**Re: Nob Hill Condos, 110 Richmond Ave SE,
Certificate of Occupancy – Transportation Development
Engineer's Stamp dated 08-06-07 (K16-D071)
Certification dated 05-14-09**

**Re: Nob Hill Condos, 110 Richmond SE,
(K-16/D071)
Approval of Permanent Certificate of Occupancy,
Engineer's Stamp Dated: 12-19-07
Engineer's Certification Date: 5-19-09**

**RE: Drainage Plan for Nob Hill Condos,
K16/D71**

ISSUE DATE: 5 July 2007
REVISIONS:
PROJECT # 2007-0703
Grading Plan
SHEET C-103
5 OF 52

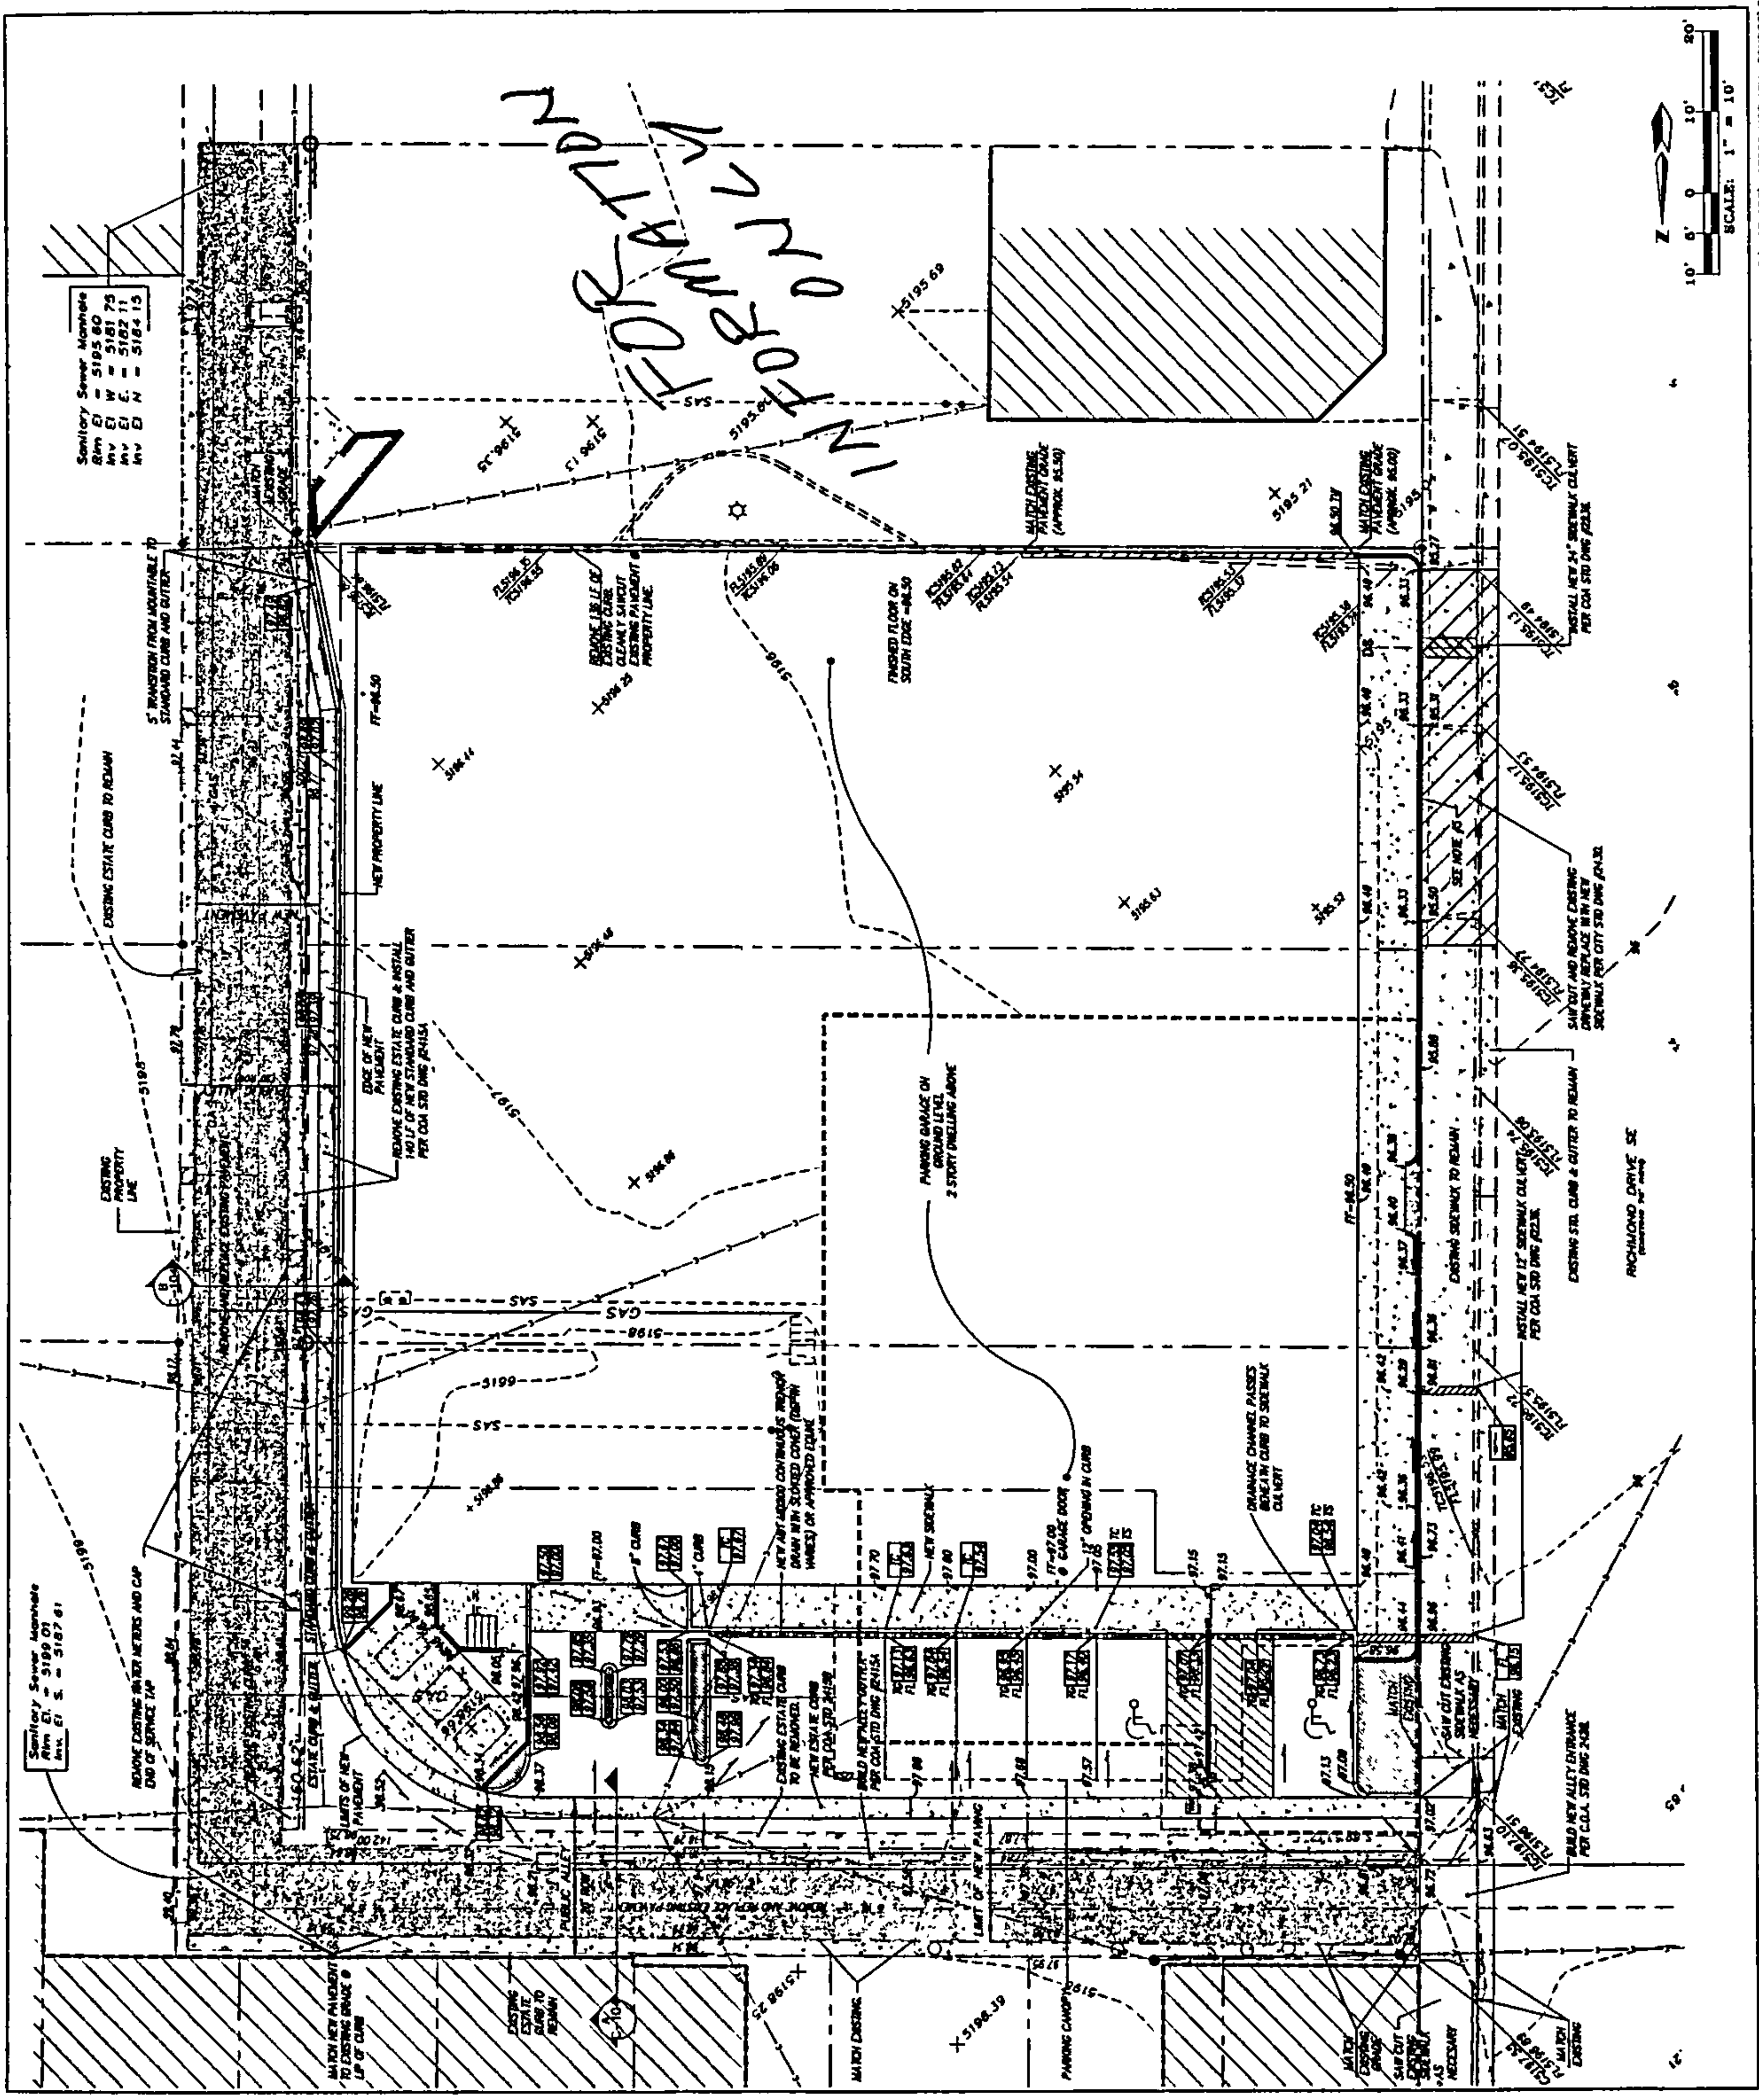
- ✓ • The scale is mislabeled.
- Remove all references to Silver Tree Park from the AHYMO calculations.
- Will the new sidewalks be constructed per standard drawing 2430? Will the "standup curb and gutter" be built per standard drawing 2415A? Please cite all applicable standard drawings or provide a detail.

- Please provide a copy of the manufacturer's cut sheet for the new sump pump.
- Due to the dedication of additional right-of-way as well as the structure's location on top of existing lot lines, a replatting action is required. Has that process been initiated?

- What are the finished floor elevations for the new structure and the existing structure to the south?
- You call out a new alley entrance at Richmond to be constructed per standard drawing 2425. That detail is for a typical drive pad. Is this correct or was it intended to reference an alley intersection (2428)?

- Where will the roof drains be located and to what point will they discharge? Will they connect to the trench drains?
- What do the three (3) rectangles at the northeast corner and the open rectangle at the northwest corner of the site represent? What does the triangle / pointer at the eastern entrance represent? Please add notes and / or legend entries to clarify.

- Please show the location of the relocated utilities and define the extents of the pavement cuts.

- Will you be providing an opening in the pre-cast wall to allow for easterly drainage or is the intention to drain that area west to Richmond thus requiring a sidewalk culvert? Why does the curb not extend east to the pre-cast wall?
- Arial photographs suggest but are unclear as to the presence of valley gutter within the adjacent alleys. Is that infrastructure present? If not, its construction may be necessary since you will now be draining east and adding flow to the alley instead of draining west Richmond. Please show this on the plan.

We have performed a supplemental evaluation of the hydraulic condition along the north side of the on-site portion of the site due to changed conditions relative to the approved plan (dated 12/19/07). This drainage basin area covers all of the north side's private parking spaces, except for those parts of the spaces that are covered by roof. The covered spaces drain through a downspout that discharges directly north into the alley and not to the private parking area. This private parking area was originally designed to be collected in a east-west running trench drain that would outfall to Richmond by gravity. Contrary to the original drainage basin plan, there is also a small additional area within the building that now drains by internal piping to this north-side parking area. During construction it became apparent that the as-built features of the project would preclude gravity discharge of the trench drain directly to the street, so now a sump pump would have to be installed to drain the parking area. I have determined that now the total area draining to the pump is 3,621 SF. I ran AHYMO on this area to find that the discharge during the 100-year storm is 0.43 cfs (see attached), which is also equal to 192 gpm.
